ADDENDUM

Project Name:	UNK University Village Student Housing
Project Number:	15097
Owner:	University of Nebraska at Kearney
Addendum Number:	01, Revision 01
Date:	April 21, 2016
By:	Matt Neaderhiser, Holland Basham Architects
To:	Project Bidders

This Addendum to the project bidding documents and attached reference drawings dated April 21, 2016, issued to inform bidders of revisions to the bidding documents.

2 A3.13 WEST ELEVATION

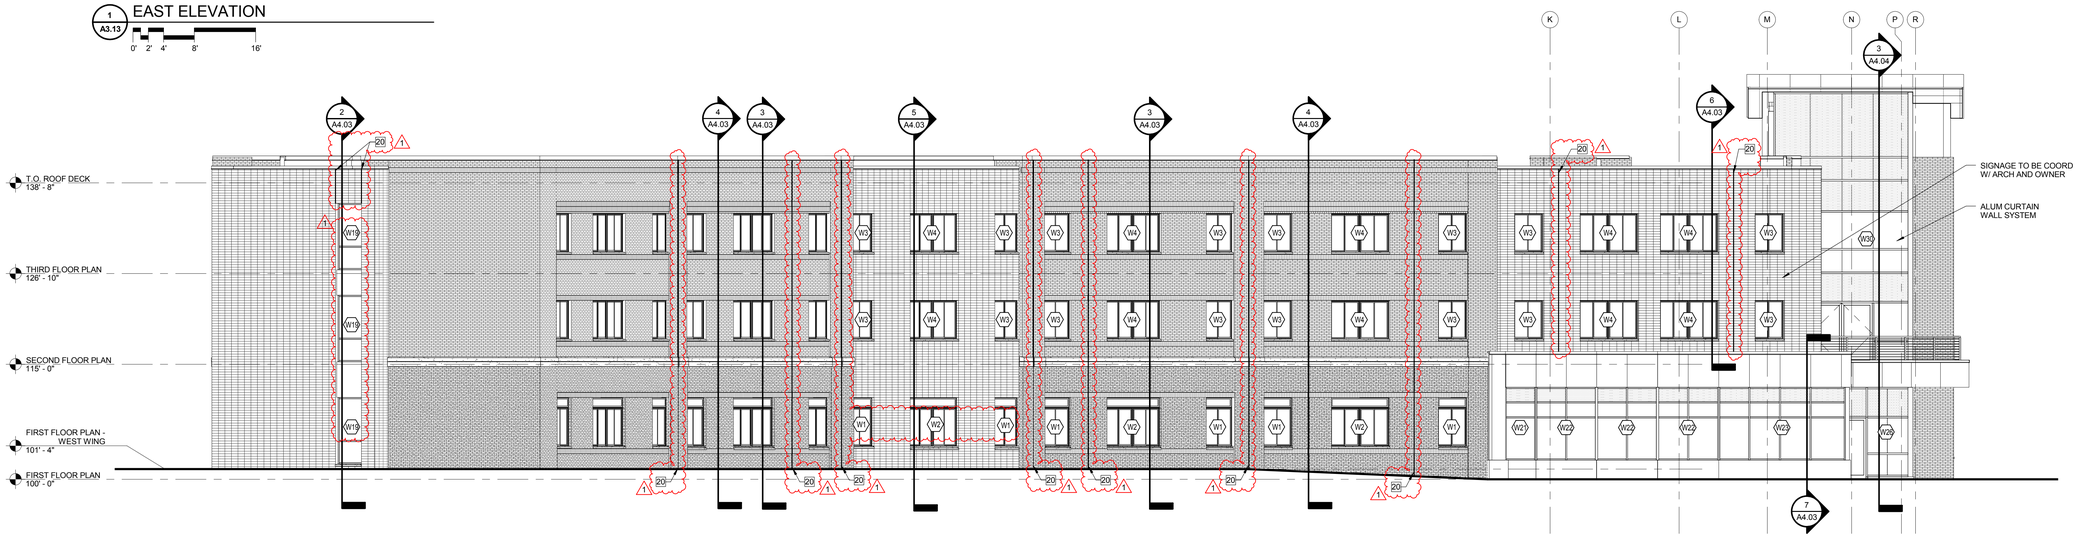
SHEET A3.13 – BUILDING ELEVATIONS
1. This sheet is REVISED and REISSUED with this revision.
2. Added control joints in the masonry.
3. 2/A3.13 – Updated window tags.

1 A3.21 ENLARGED ELEVATION

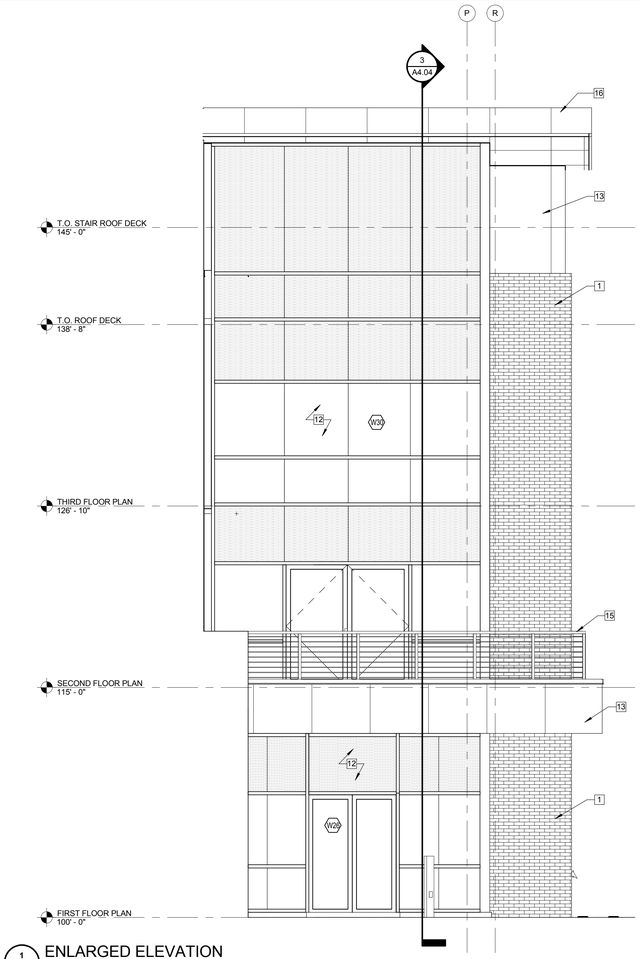
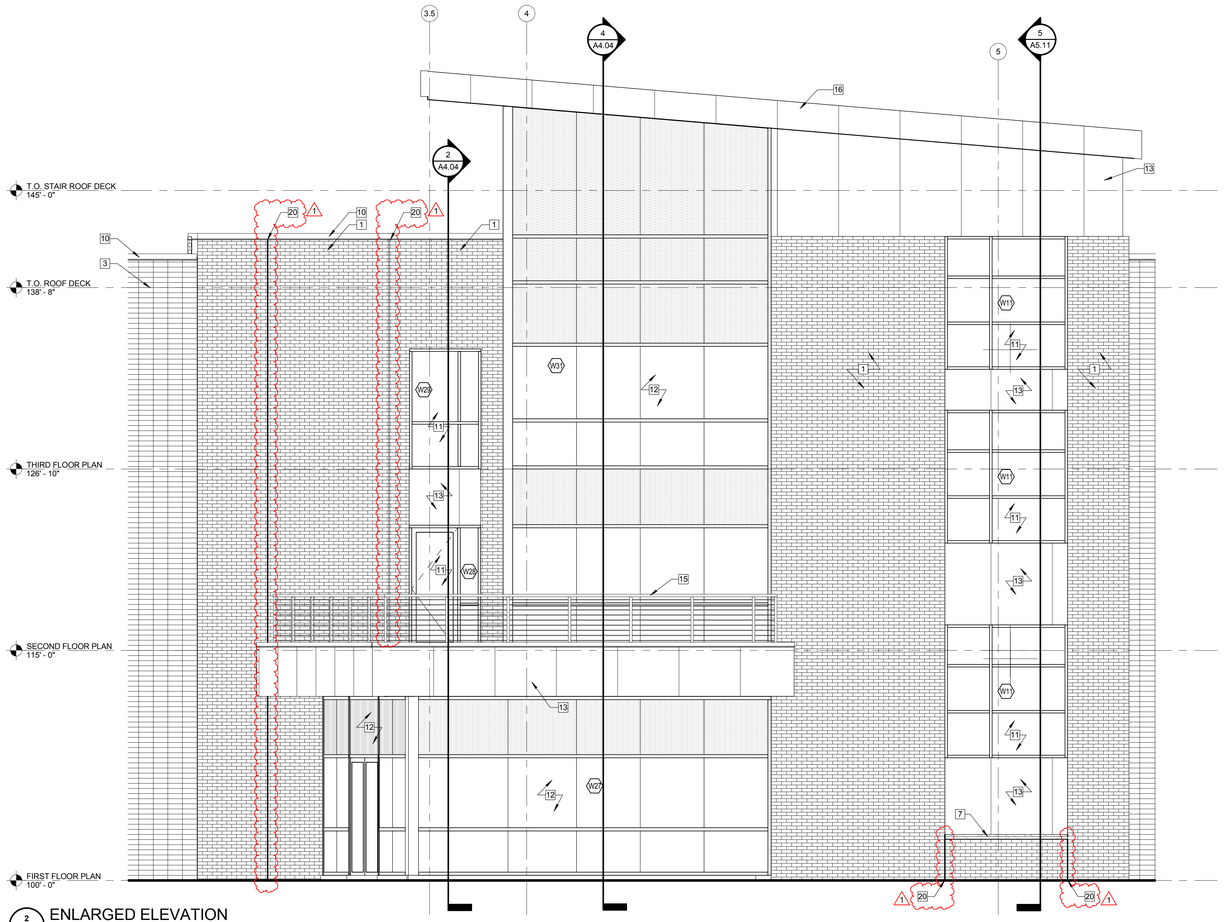
SHEET A3.21 – ENLARGED BUILDING ELEVATIONS
1. This sheet is REVISED and REISSUED with this revision.
2. Added control joints in the masonry.

1 A3.22 ENLARGED ELEVATION

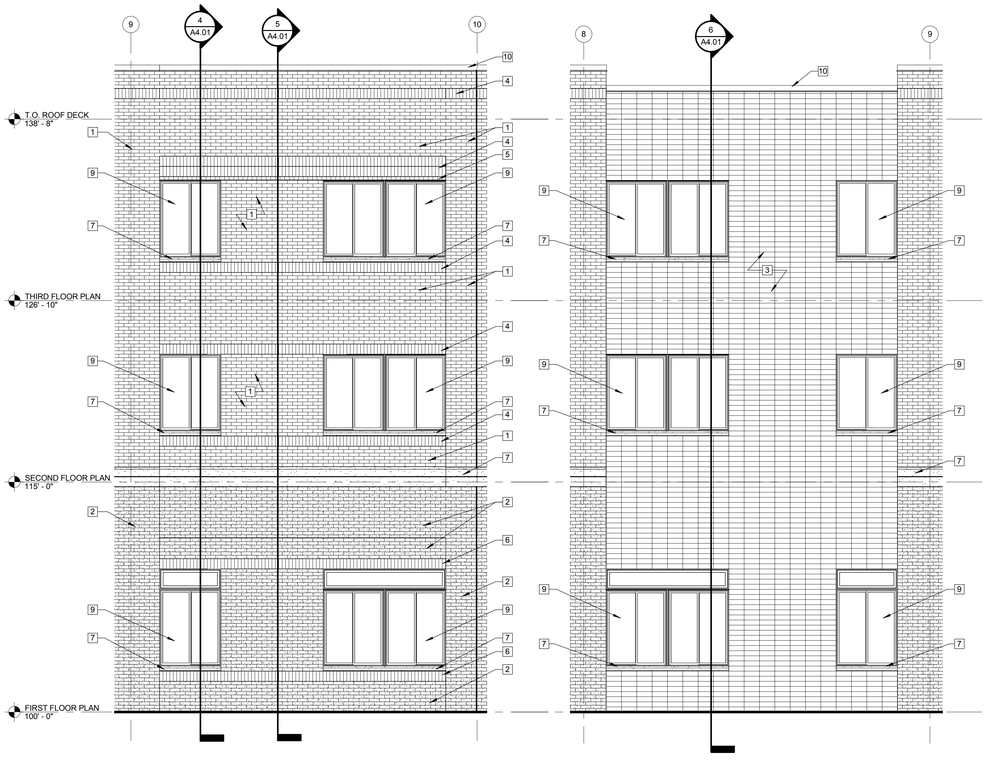
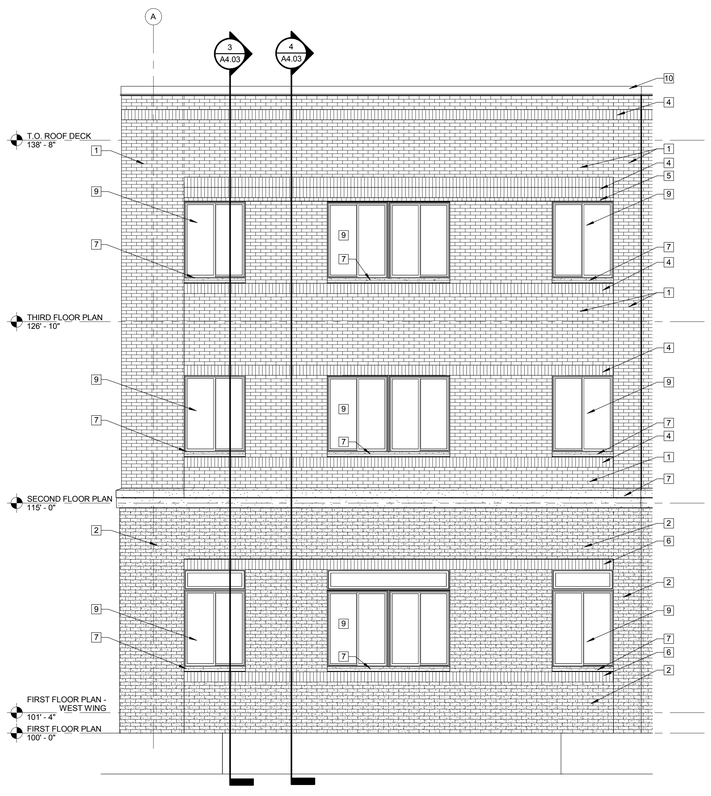
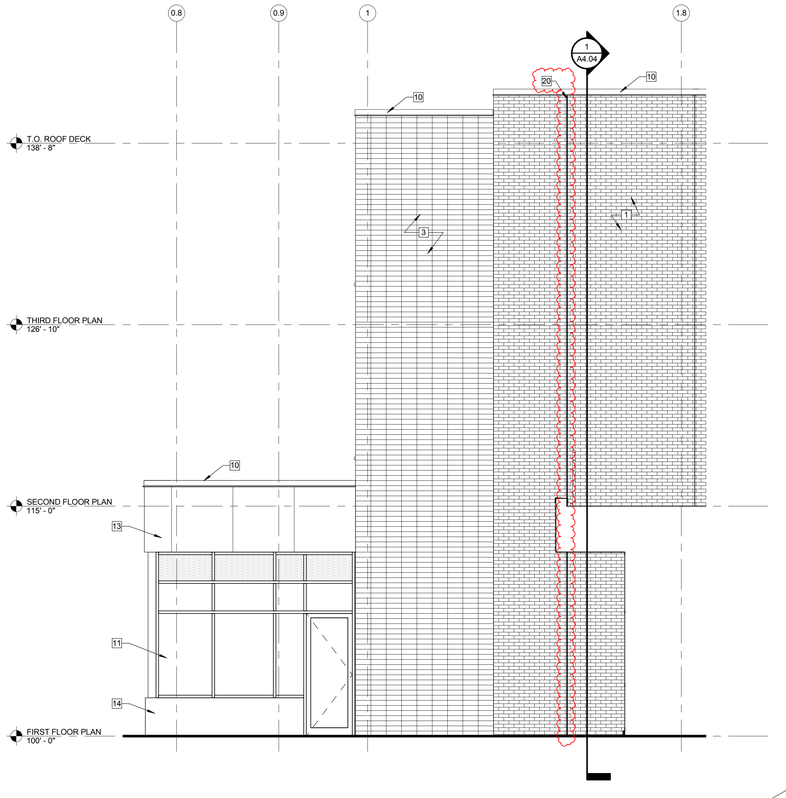
SHEET A3.22 – ENLARGED BUILDING ELEVATIONS
1. This sheet is REVISED and REISSUED with this revision.
2. Added control joints in the masonry.

1 WALL SECTION A4.03 — 0' 6" 1' 2' 4'

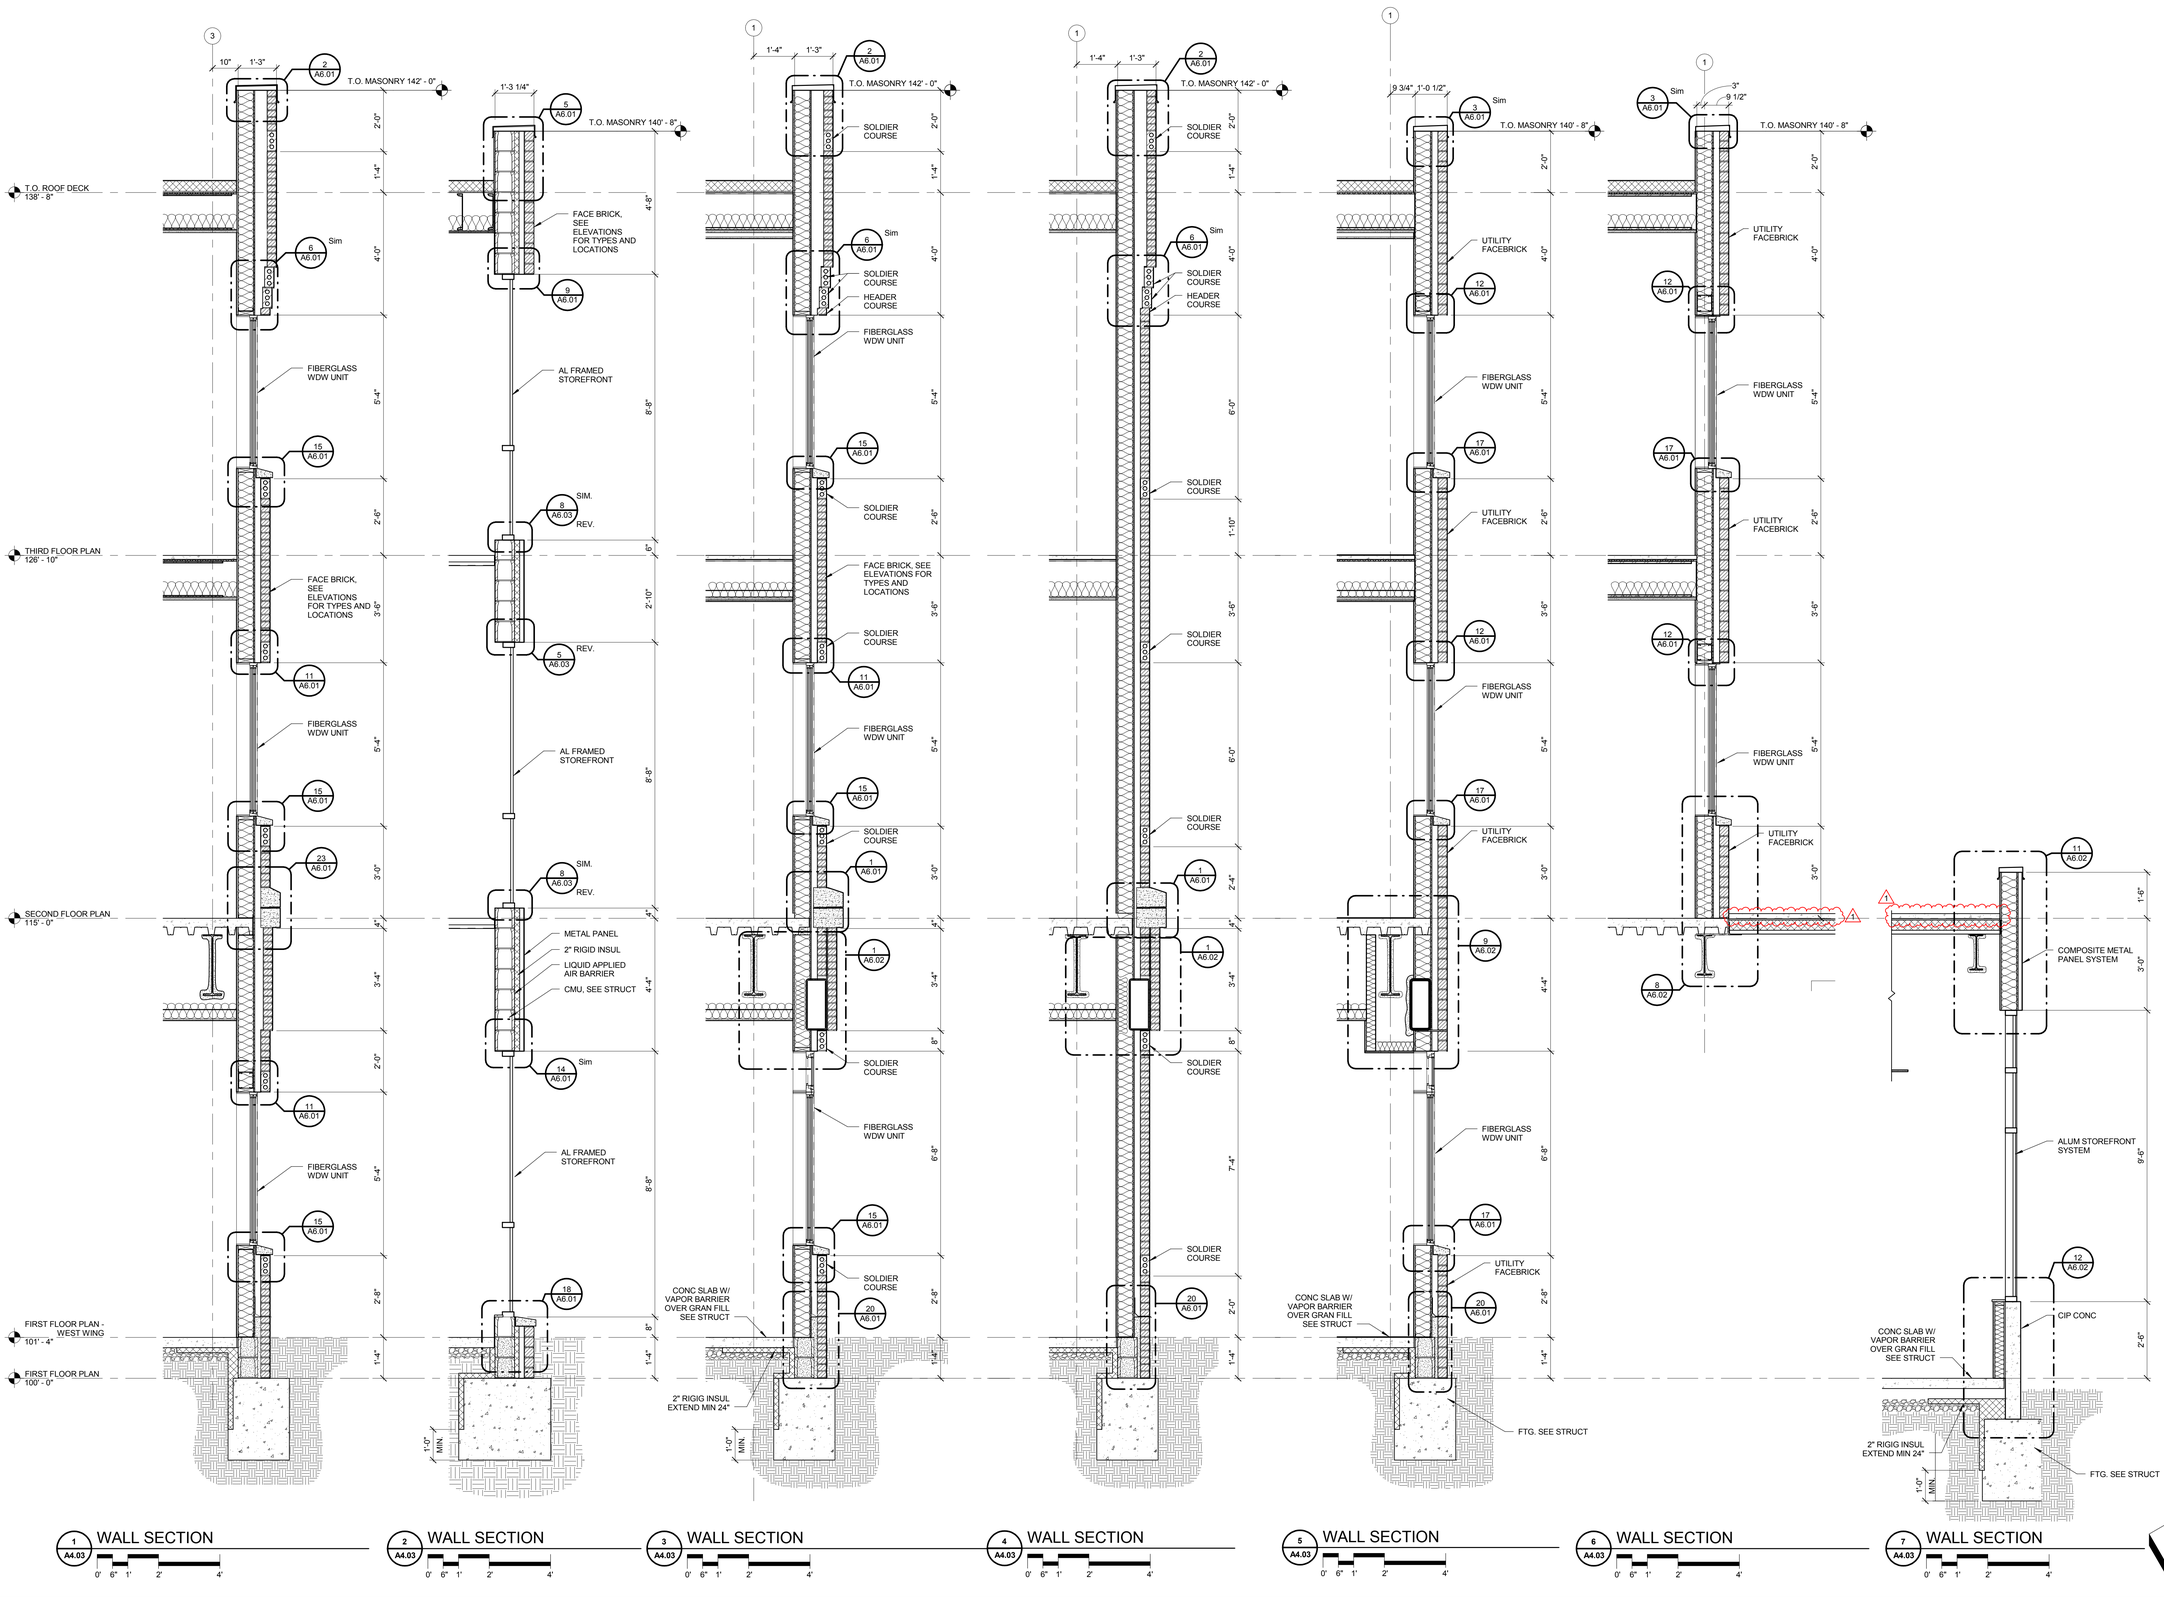
SHEET A4.03 – WALL SECTIONS
1. Detail 6&7 – Add pavers to roof.

1 S1.02B — SECOND FLOOR FRAMING – EAST WING

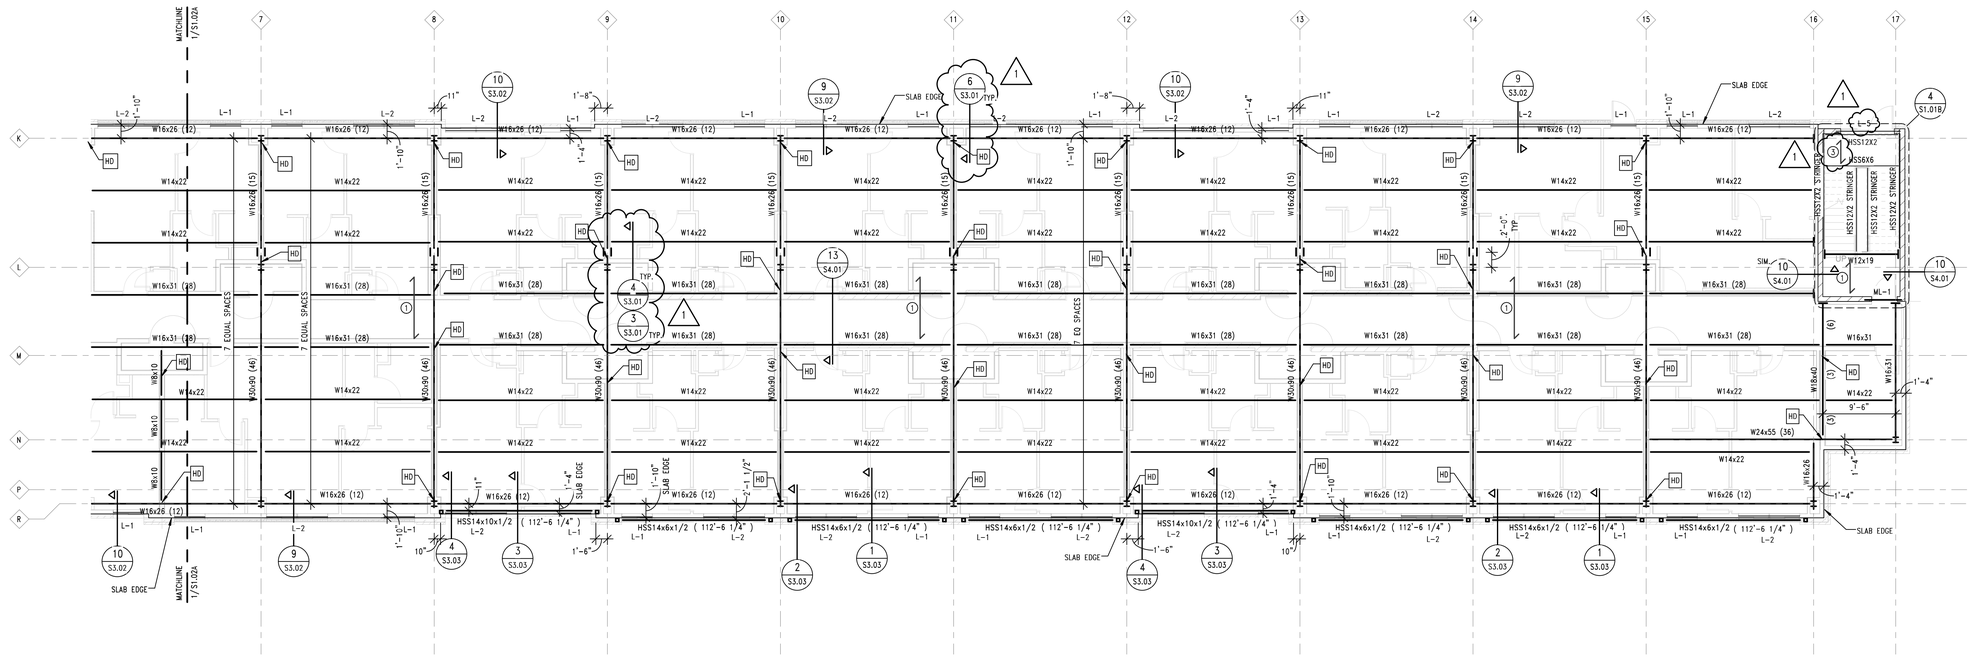
1. Added typical section cuts 3 & 4 on S3.01 at grid 9.
2. Added typical section cut 6/S3.01 at grid 11.
3. Revised window header labels.
4. Revised plan notes.
